FIELD SERVICE BULLETIN

FSB Number LVCCFSB2007 - 369/Rev3
Author Tom Lee
Date Monday, March 03, 2008
Subject **GSM - Q700 - Resetting After Moving Slider Up and Down**
Model Affected Q700 (6.8 HW)
Level Of Repairs 2

Figure 1 – Battery Contact Block Change

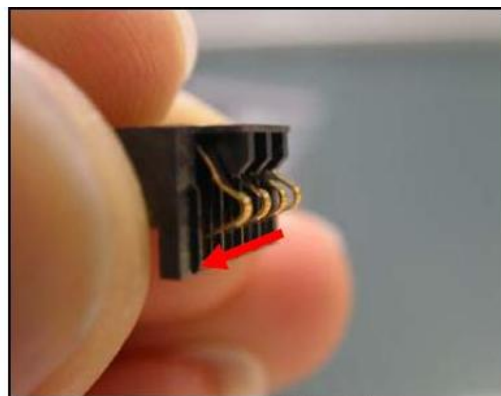
MEZNT46001A
Battery block (old)
pins curling up (see arrow)

MEZNT46002B
Battery block (newer)
pins curling down (see arrow)

HW 7.1: newer battery contact block and rear housing. See Figs. 1-2 for illustration.

Figure 2 – Rear Housing (Case D) Change

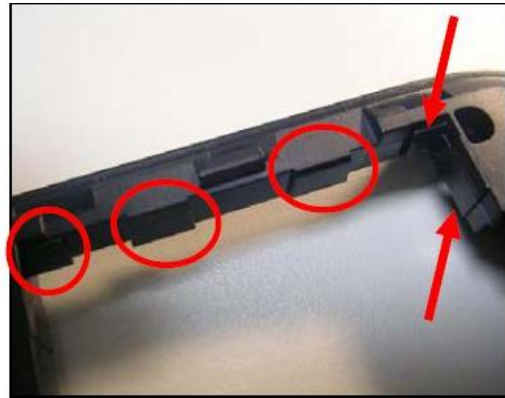
MEZNT61004B - old rear housing

MEZNT61004C - newer rear housing
-added 2 ribs (see arrows)
-modified 3 ribs and made it bigger (see circles)

- Replace the rear housing MEZNT61004B with rear housing MEZNT61004C (see Fig. 2 for illustration)
- If MEZNT61004C is unavailable, follow the mylar placement step below
